HILLWOOD SUBDIVISION, REUBDIVISION OF LOT 7 AND A PORTION OF LOT 6

APPLICATION NUMBER 3 DATE March 5, 2009
 APPLICANT Hillwood Subdivision, Resubdivision of Lot 7 and a Portion of Lot 6
 REQUEST Subdivision

HILLWOOD SUBDIVISION, RESUBDIVISION OF LOT 7 AND A PORTION OF LOT 6

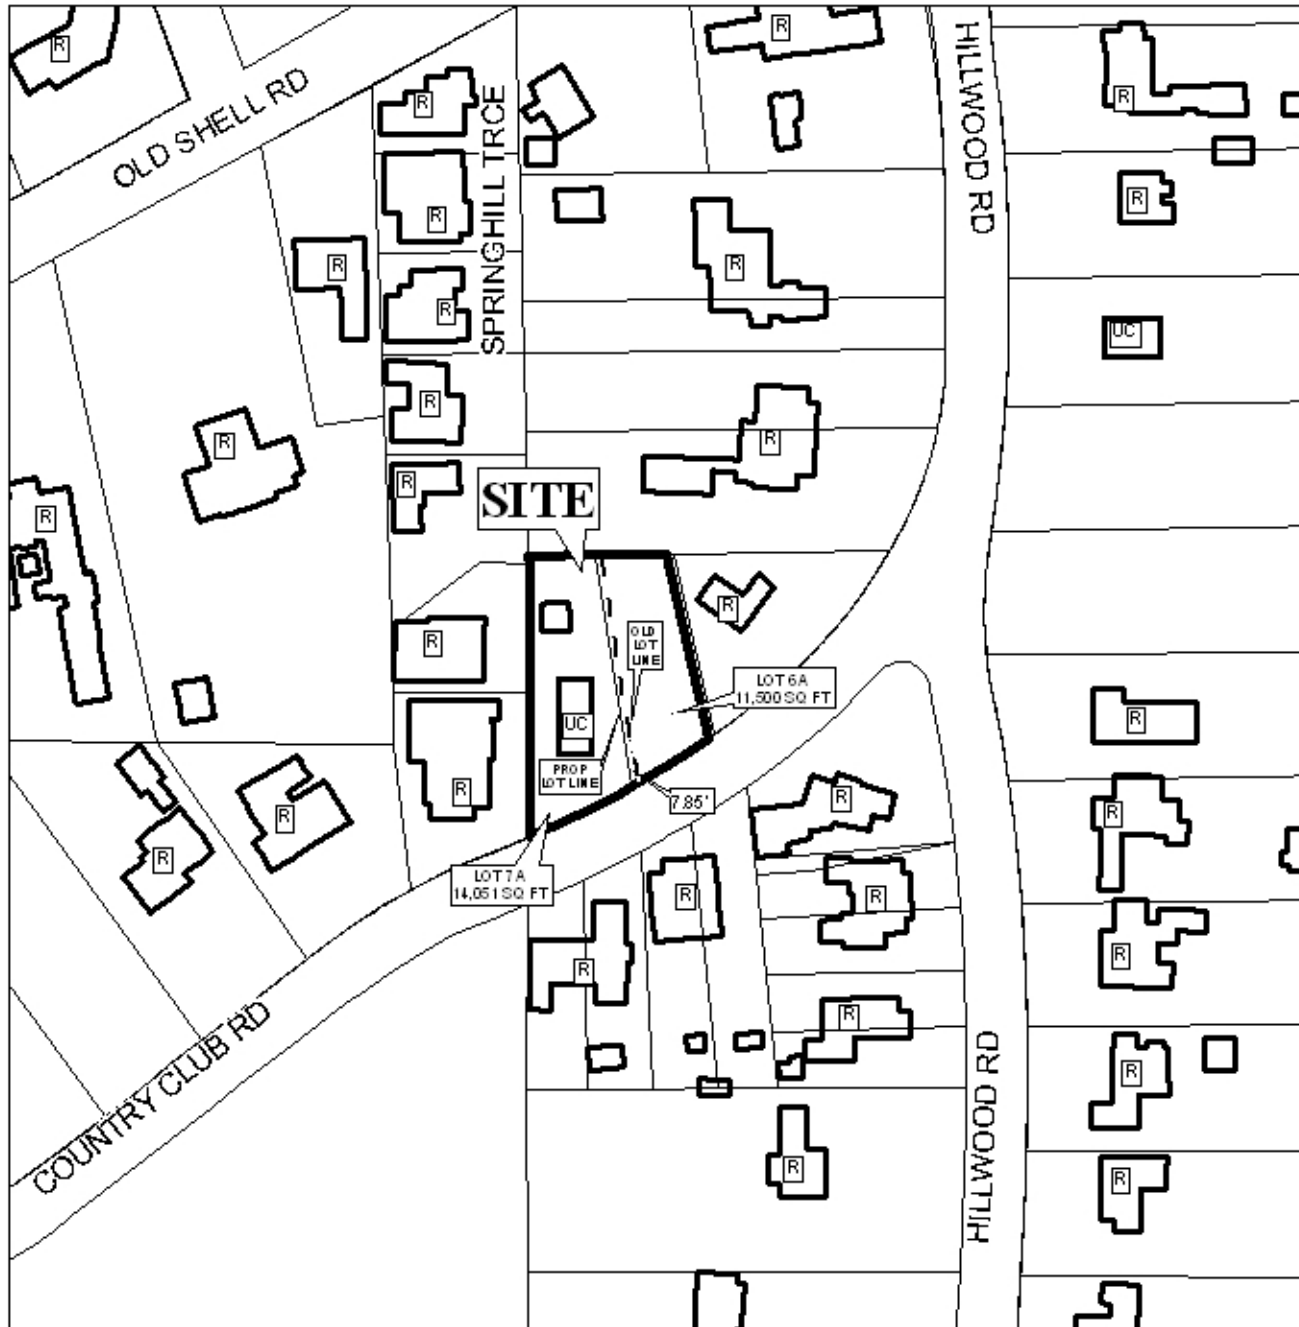
The proposed subdivision has frontage on Country Club Road with a compliant 50' right-of-way; therefore, no dedication is required. The plat illustrates the 25' minimum building setback line along Country Club Road and this should also be shown on the final plat. As a means of access management, a note should be required on the final plat stating that each lot is limited to one curb cut to Country Club Road, with the size, location, and design to be approved by Traffic Engineering and conform to AASHTO standards.

Each lot is labeled on the plat with its size in square feet, and should also be so-labeled on the final plat, or a table should be provided furnishing the same information.

Lot 7 currently has a dwelling under construction on it. The submitted site plan approved in December 2008 for that construction indicates the minimum 8' side yard setback along the left or West side of the lot and a 12'-3" (12.25') setback along the right or East side. The proposed 7.85' shift of the East property line to the West would reduce the right side setback to 4.4', far

less than the required 12' minimum. However, the property dimensions on the site plan submitted for construction differ somewhat from the survey submitted for this application. As there should be no appreciable difference between the approved site plan dimensions for Lot 7 and the current dimensions for that lot on the subdivision plat, verification that the dwelling under construction will meet the required individual and combined side yard setbacks after the proposed lot line shift should be provided via the inclusion of the dwelling on the plat. Because of the discrepancies between the site plan and the survey, a holdover of this application to the meeting of April 2nd should be considered to allow the applicant to resolve the discrepancies and provide verification that all required setbacks will be met after the property line shift.

Based on the preceding, this application is recommended for holdover to the meeting of April 2nd to allow the applicant to resolve the property dimension discrepancies between the construction site plan and the current Lot 7 configuration on the proposed subdivision plat and to verify that the proposed shift in the common property line will not reduce any required setbacks for the dwelling under construction on Lot 7.
